CITY OF ALBUQUERQUE

**Re: Las Lomas Plaza, Building 1 & 2, Phase 2
2101 & 2105 Vista Oeste NW
60-Day Temporary Certificate of Occupancy
Transportation Development Final Inspection**
Engineer's/Architect's Stamp dated 4-26-18 (H10D031)
Certification dated 12-12-18

PROJECT
Las Limitas Plaza
2101 Vista Oeste
Albuquerque, NM 87120
TITLE
Architectural Site Plan

A001

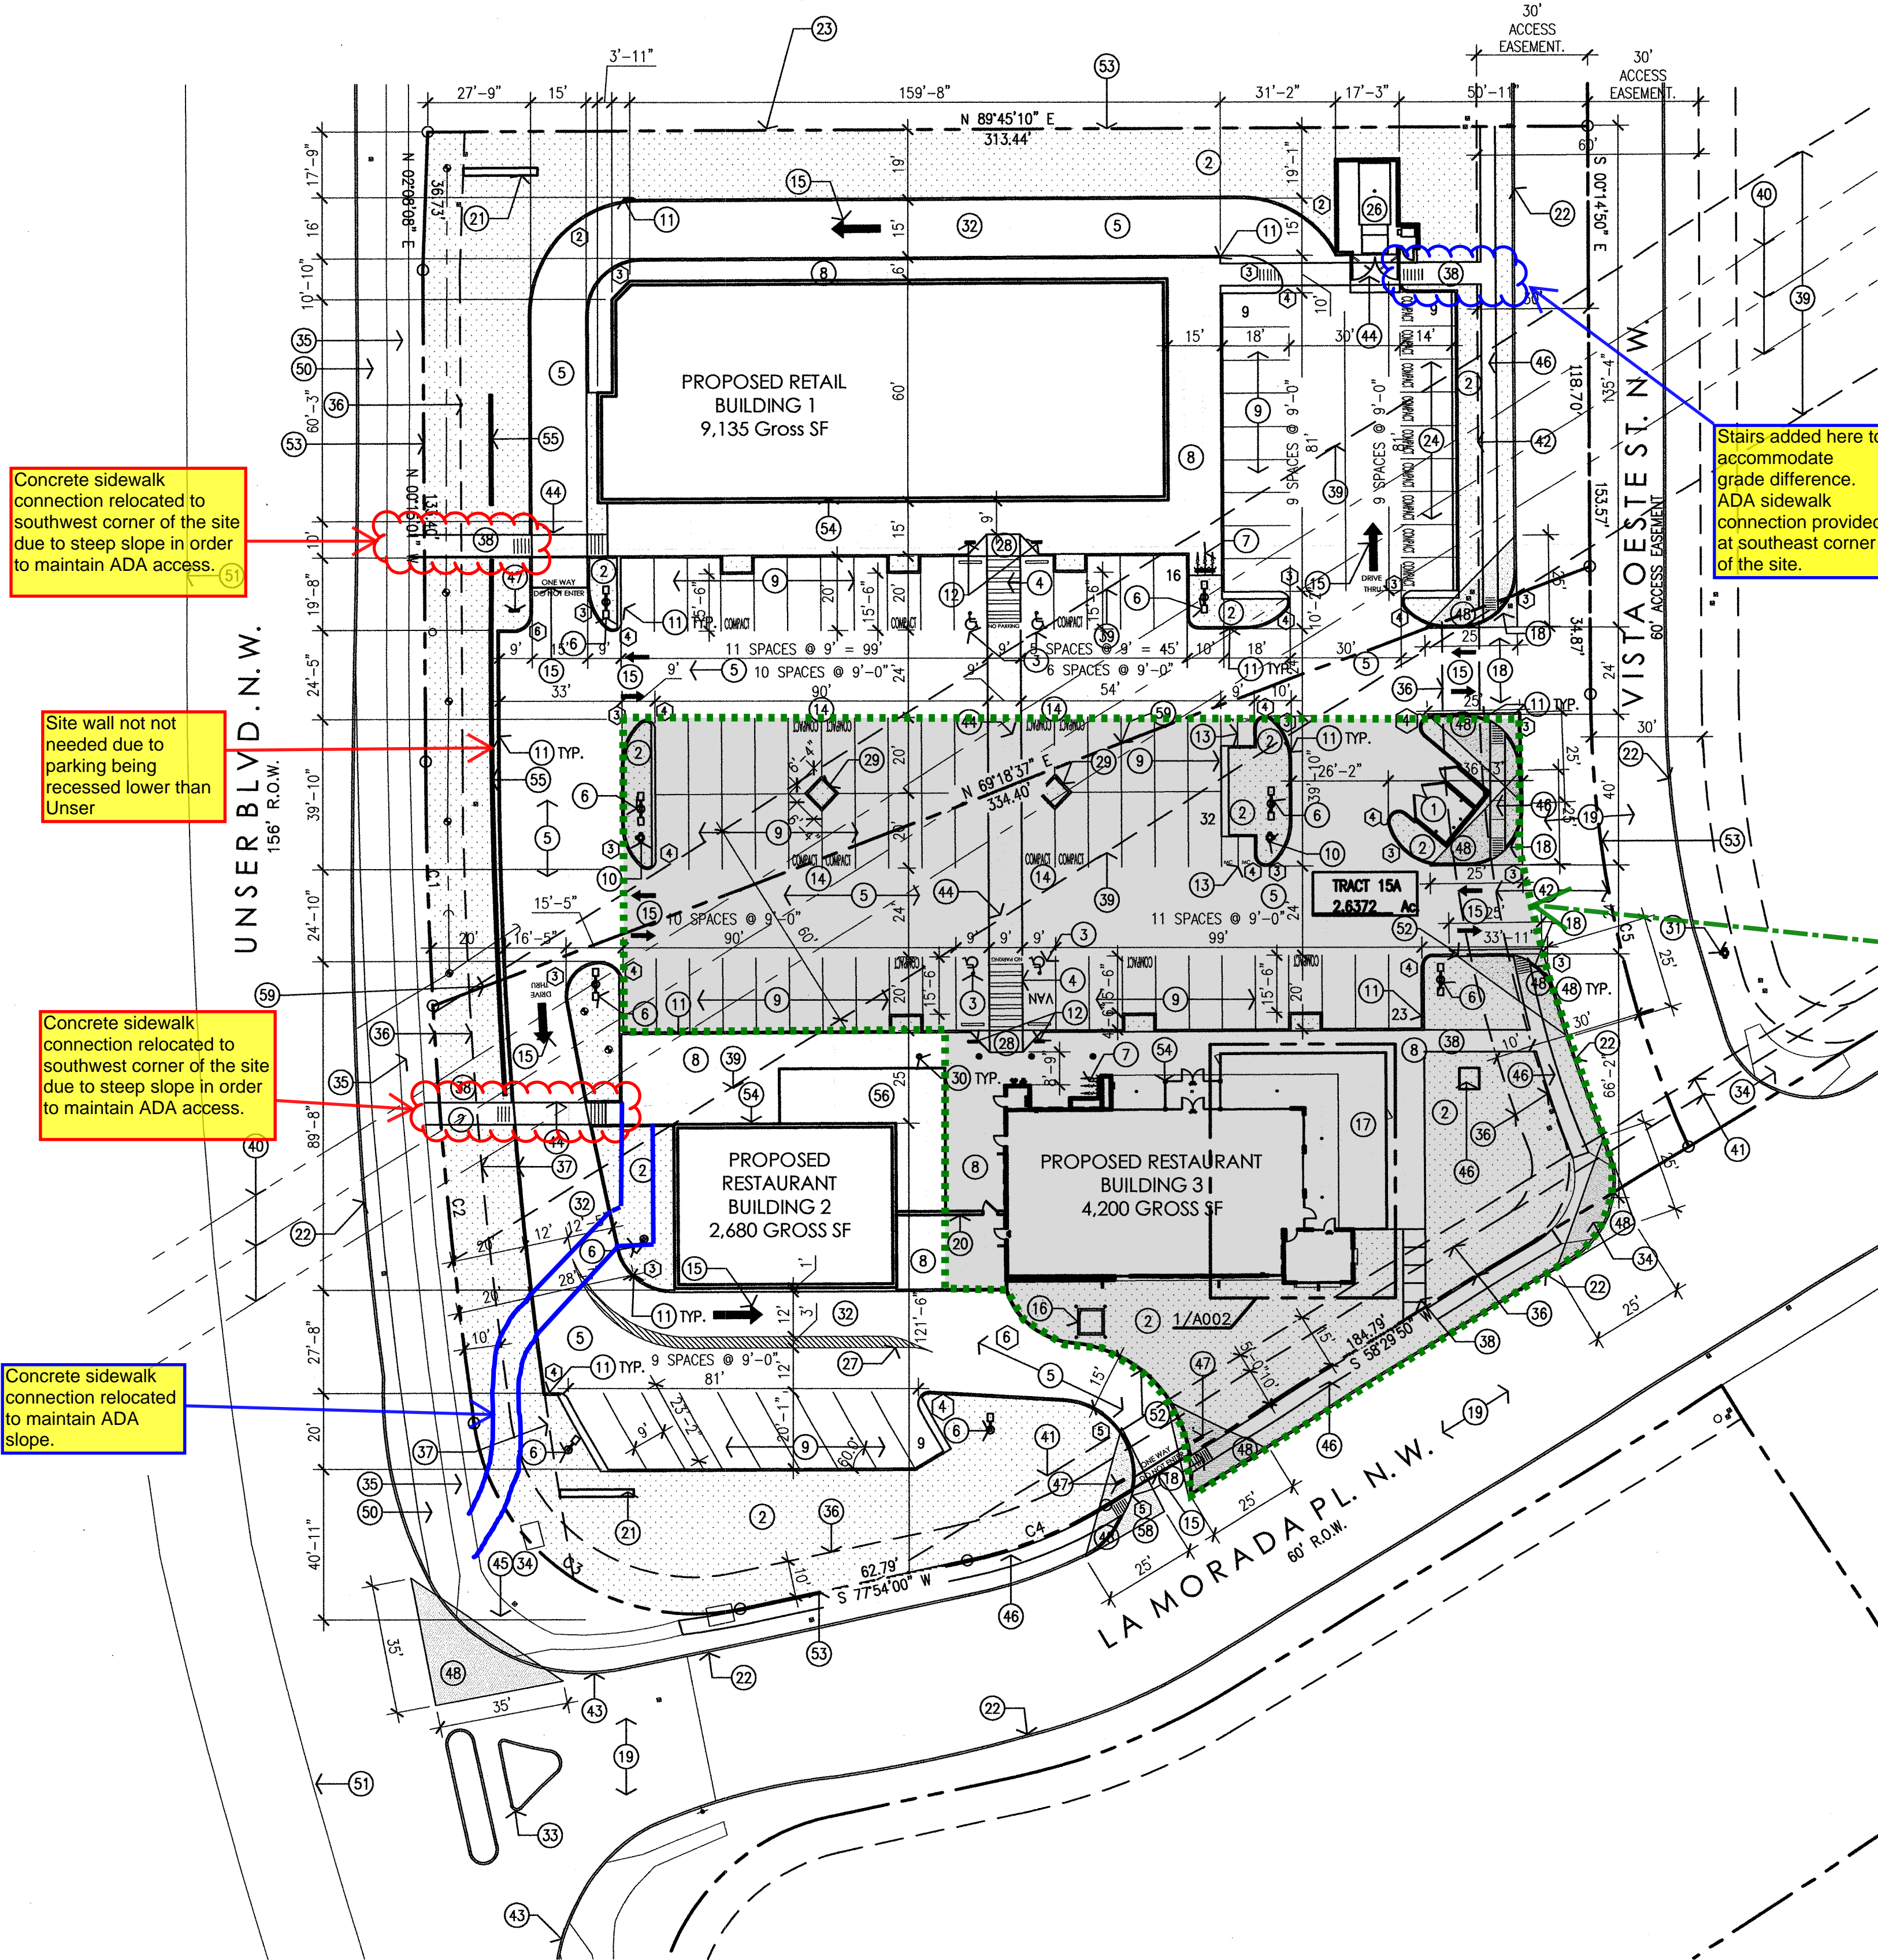
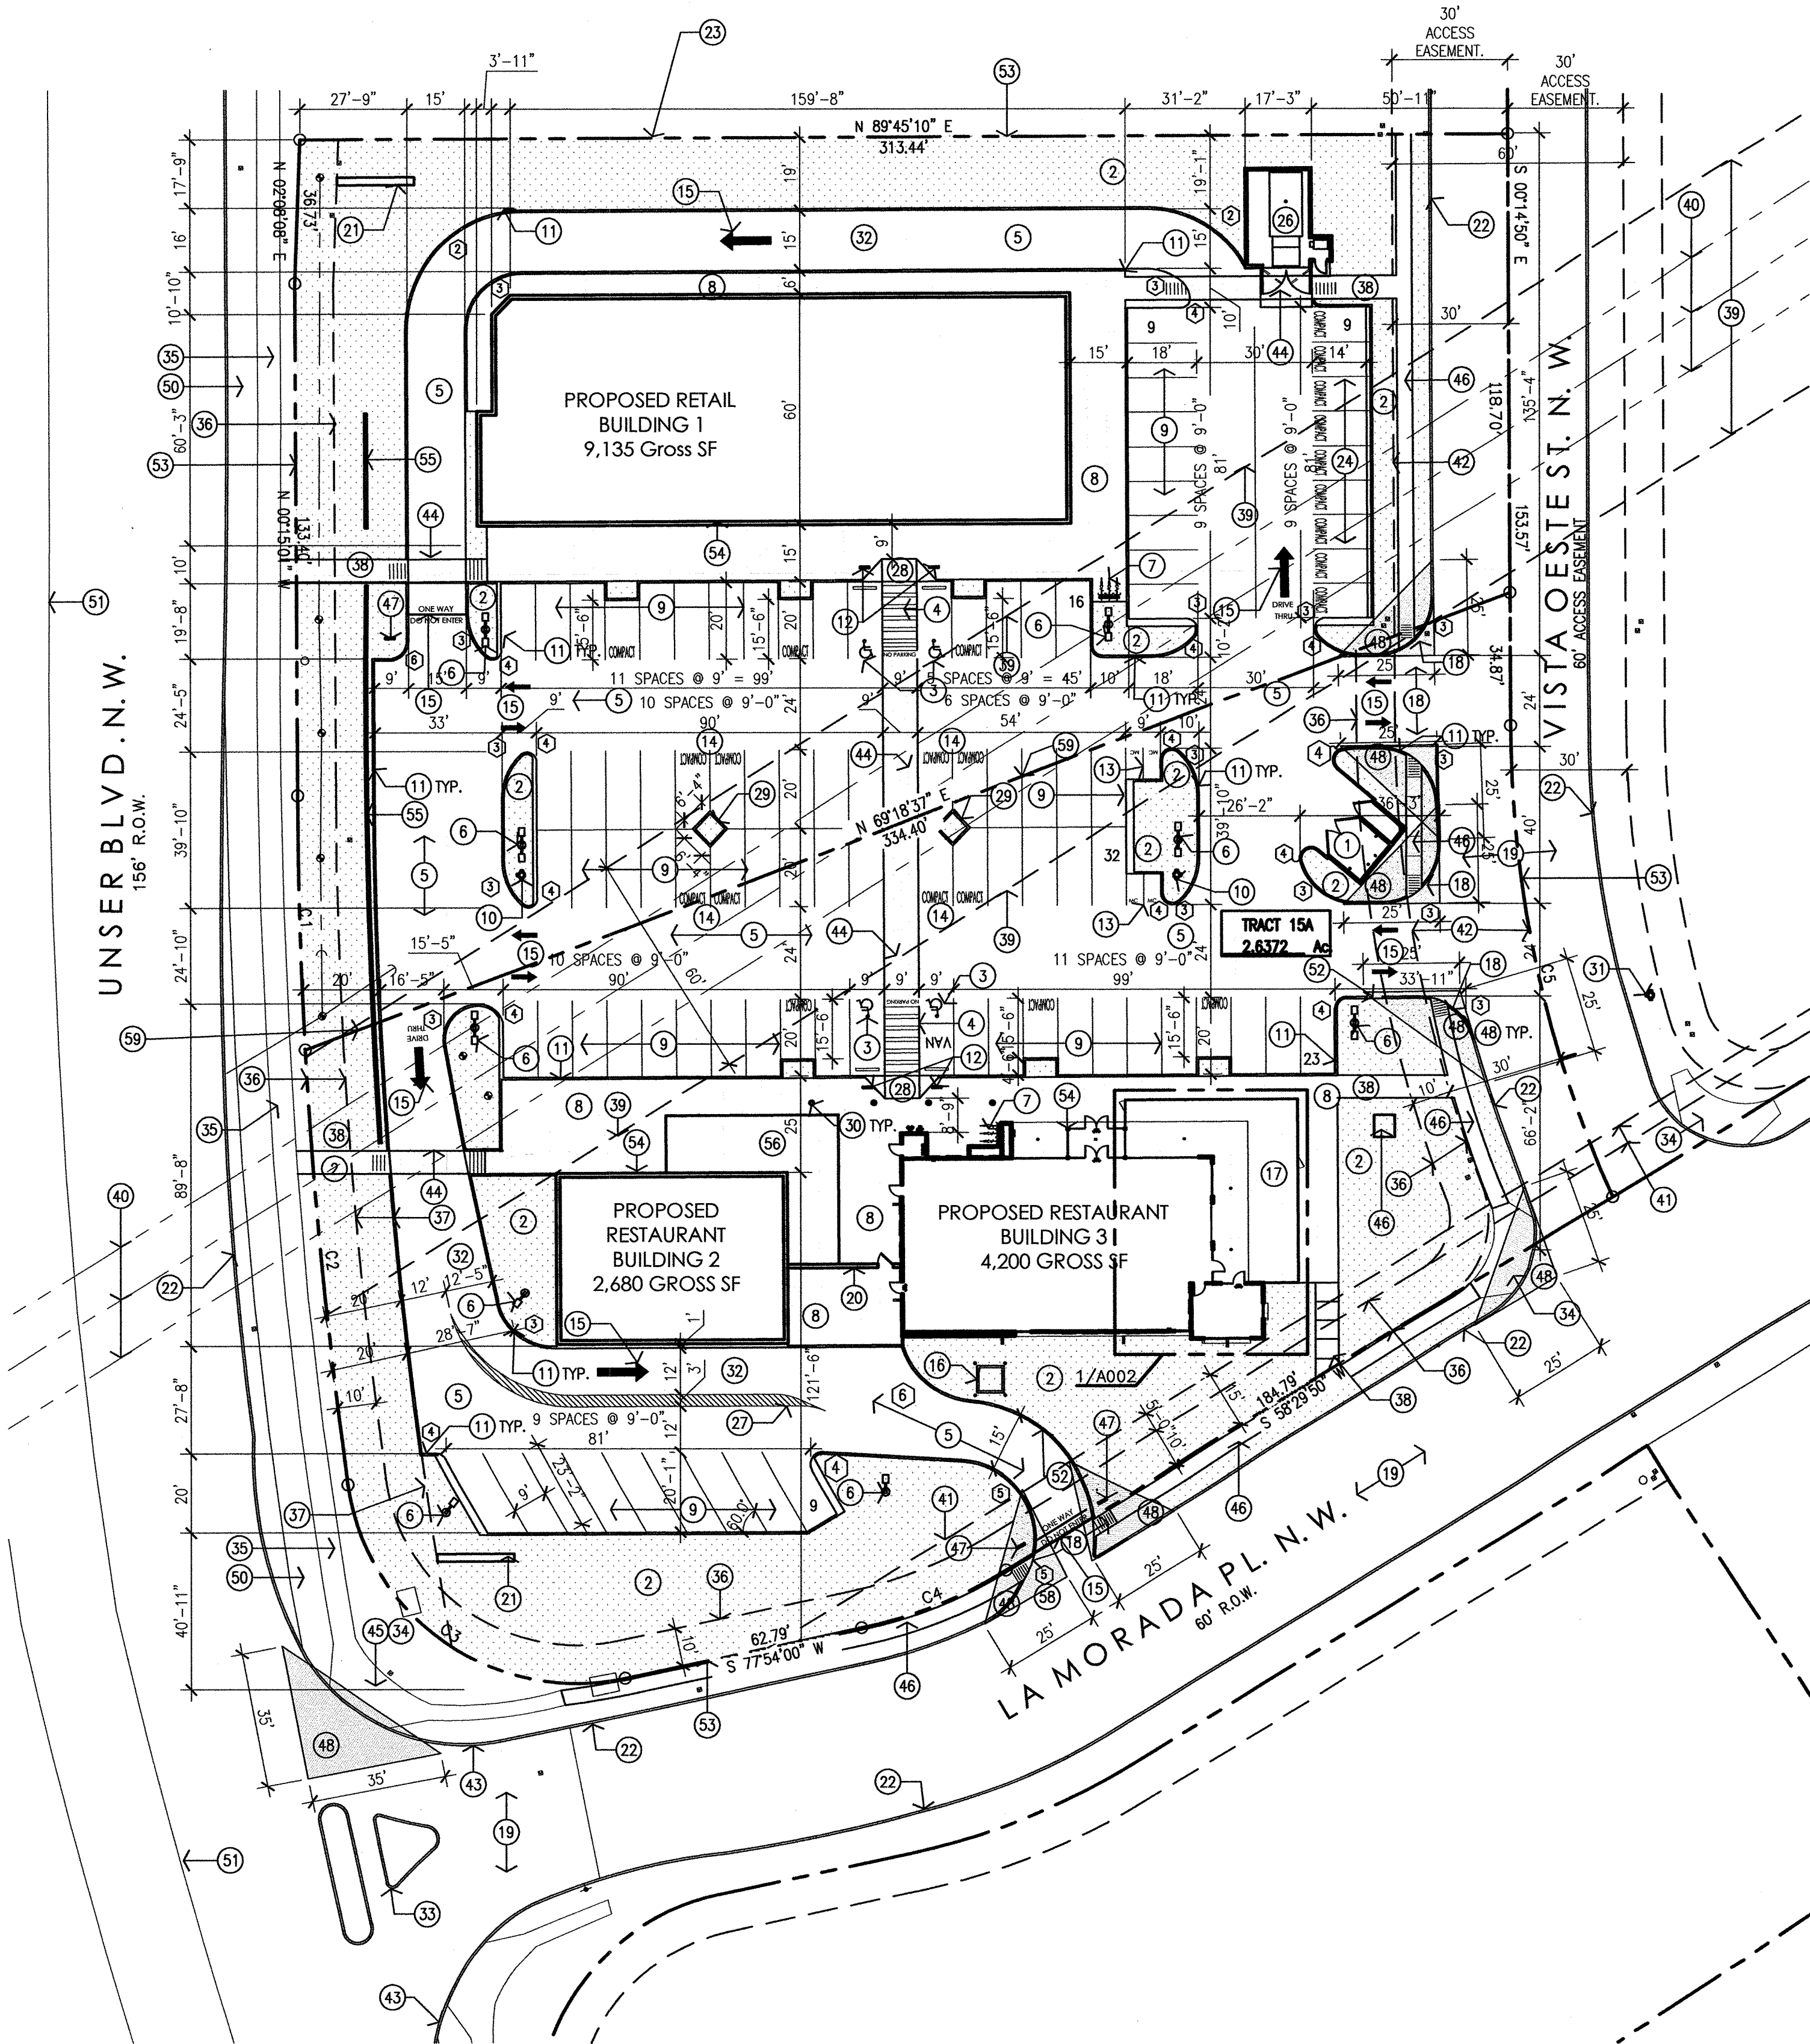
1. Please add bicycle parking, Building 1.
2. Please paint COMPACT on all parking stalls listed as compact on approved TCL plan.
3. Please add 6ft wide accessible pedestrian pathway from public sidewalk to building entrance for Building #1 off Unser. Because of steep slope stairs will be okay.
4. Photos of corrections will be sufficient when requesting final CO.
